**Eugene School District 4J
ROOSEVELT MIDDLE SCHOOL**
680 East 24th Avenue
Eugene, OR 97405
CIP No. 410.566.001

ADDENDUM NO. 6

This Addendum forms a part of the Contract Documents and modifies the original Bidding Documents dated February 18, 2015 and subsequent addenda as noted below. Acknowledge receipt of this Addendum in the space provided on the Bid Form. Failure to do so may subject the Bidder to disqualification.

A1 STAIR 2 - SECTION A
1/2" = 1'-0"

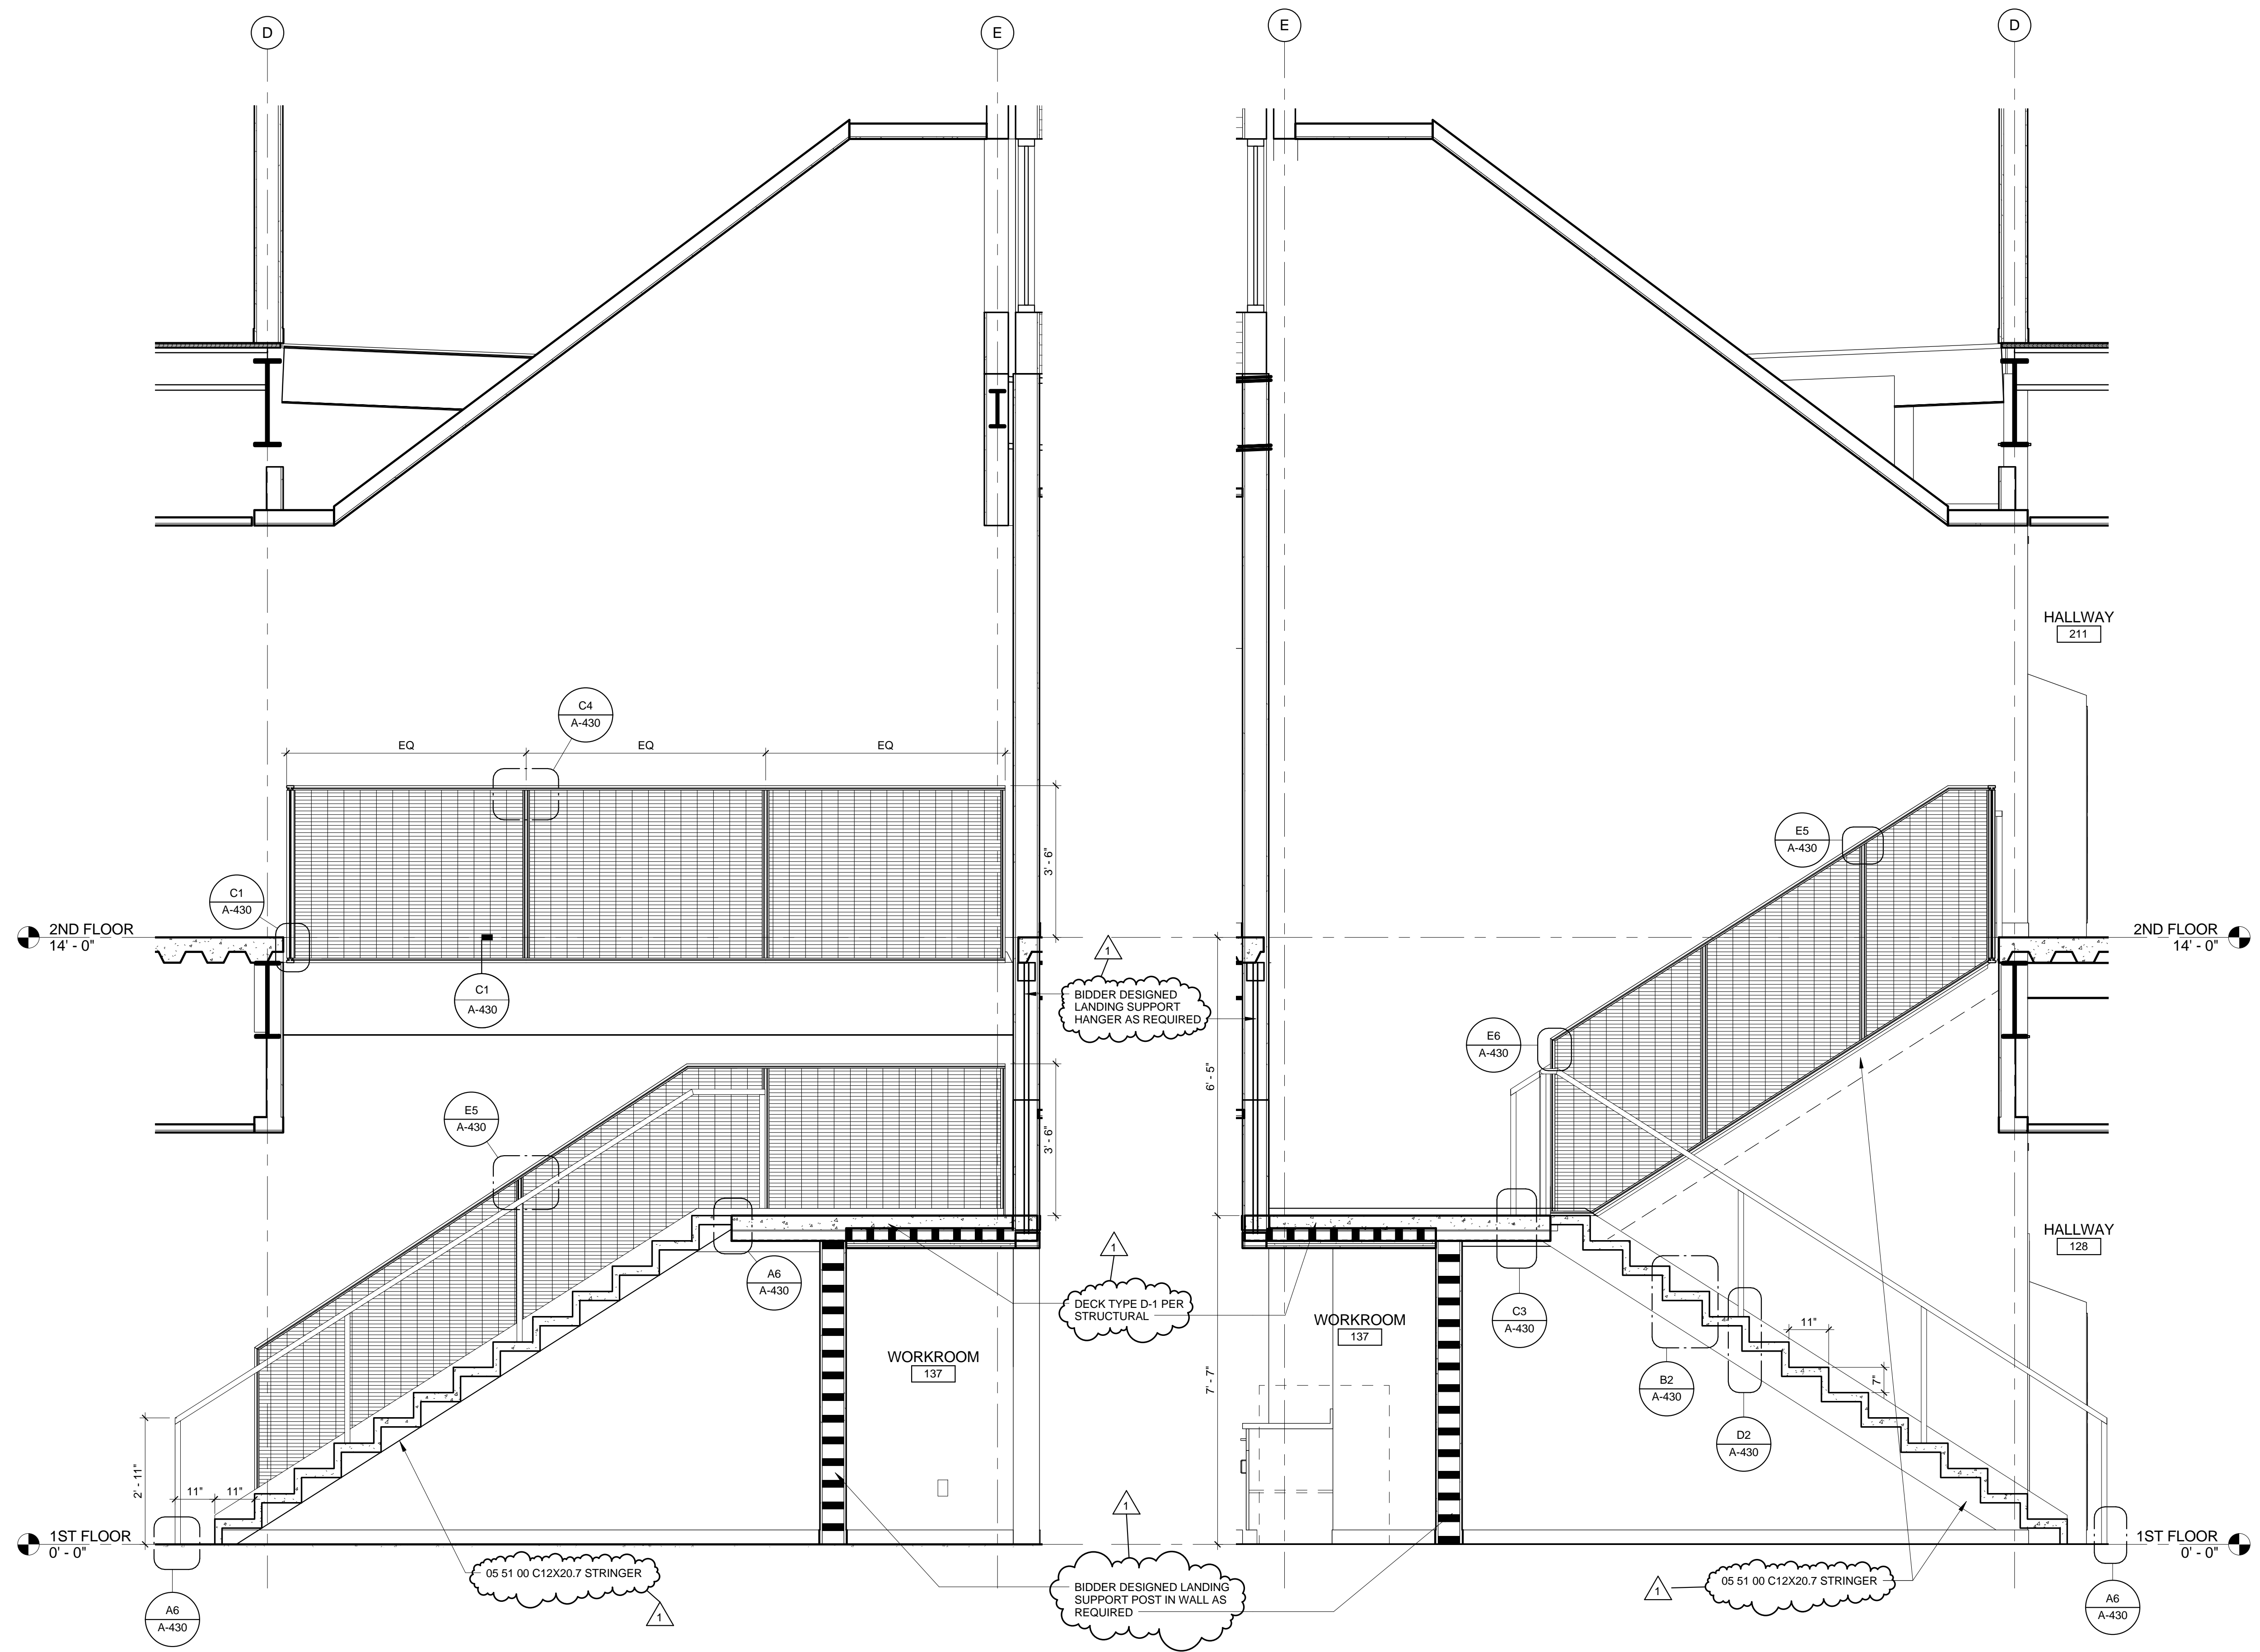
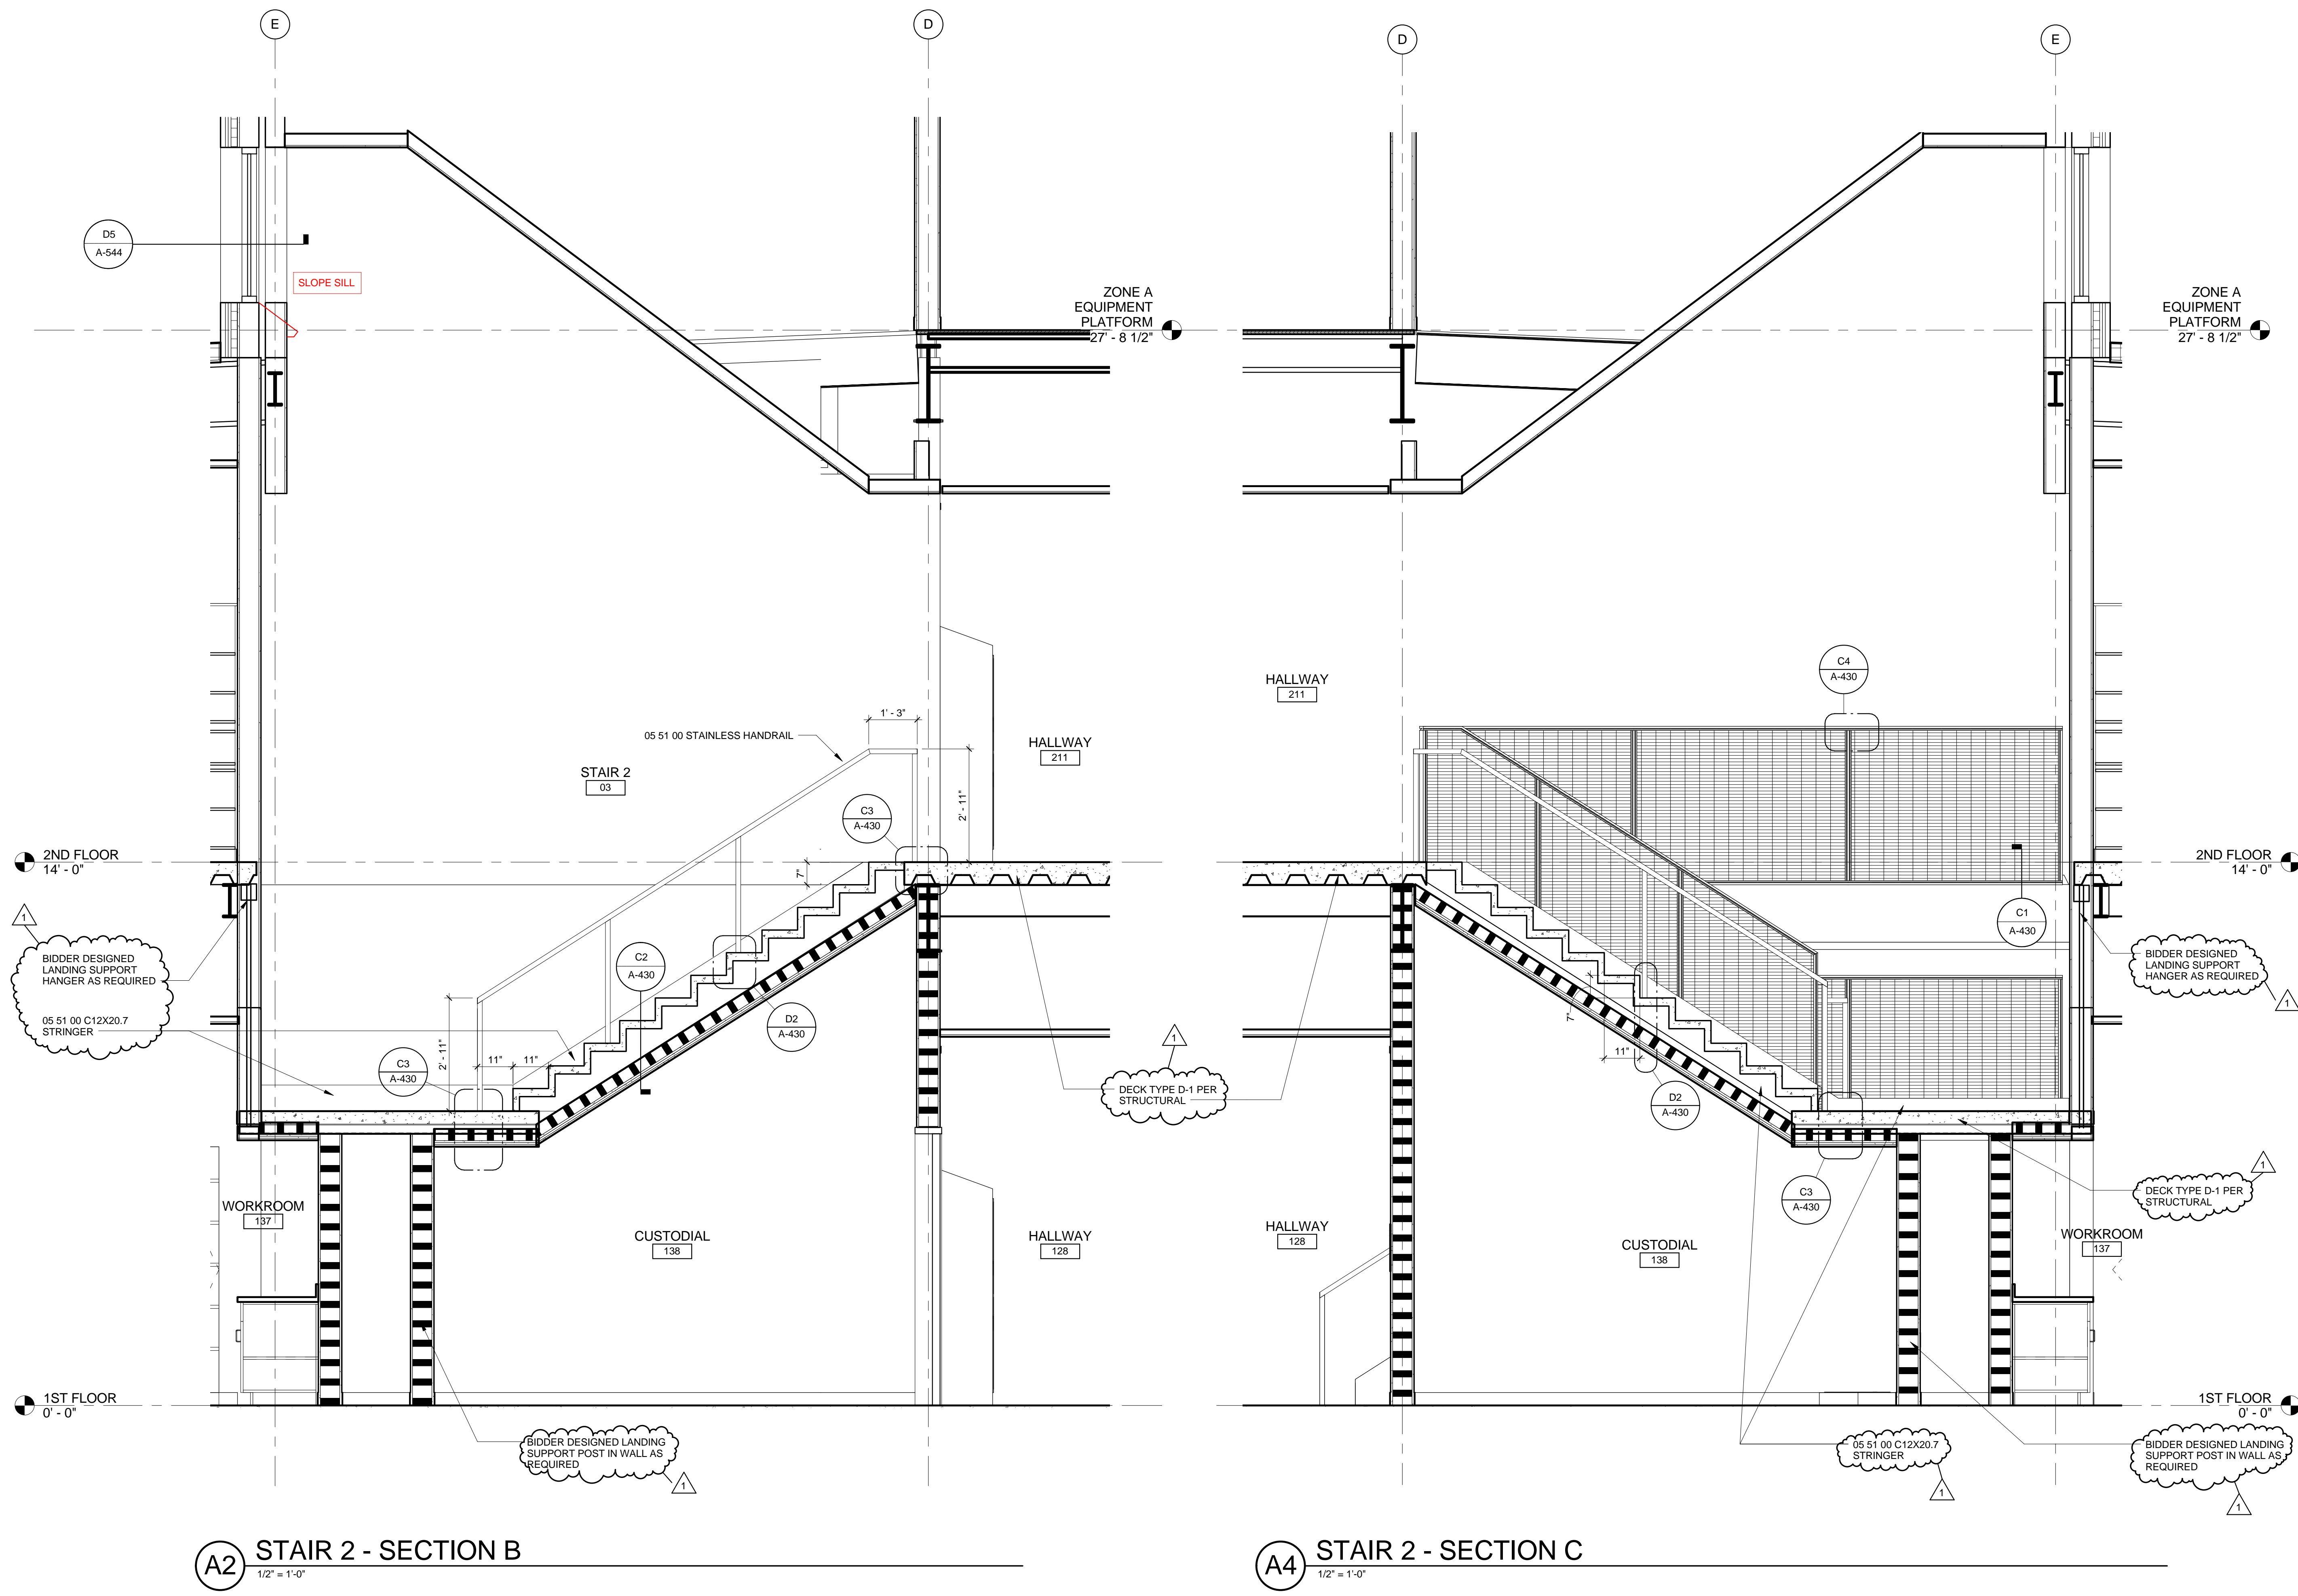
- A. Replace Sheet with attached revised Sheet A-423: C5 / A-423: Add description to stringer. A1, A3/ A-423: Add description to stringer. Add additional information to concrete landing support
